SEWAGE DISPOSAL TESTING

STATE OF MARYLAND - DEPARTMENT OF HEALTH AND MENTAL HYGIENE

SUBDIVISION Longwood LOT NO. 16

INDICATE NORTH - NAME ADJOINING ROADWAY AS BASE LINE

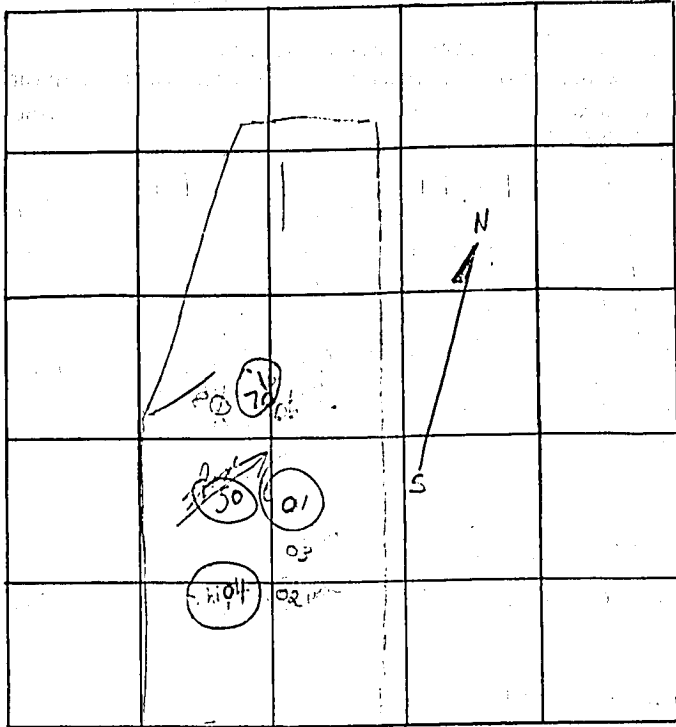
Drywell to have 150 sq. ft. effective absorption area per
9:30 bedroom. Effective absorption area starts at 5 ft. below original grade,
Drywell inlet is at 4 ft. below original grade and maximum depth
of drywell at 11 ft. below original grade.
Place the drywell 3.7 ft. from the lot line which is 415.62 ft. long and
runs N 13° 53' 06" W and 2.12 ft. from the lot line which is 356.5 ft. long and
runs S 76° 10' 00" W then facing lot from New Cut Road,
TO: THE COUNTY HEALTH OFFICER
ELLICOTT CITY, MARYLAND

REASONS FOR REJECTION OR HOLDING 4/19/74 Hold for certification of hood on F.S.

APPROVED BY Frank Skinner FOR Drywell DATE 4/30/74
(KIND OF SYSTEM)
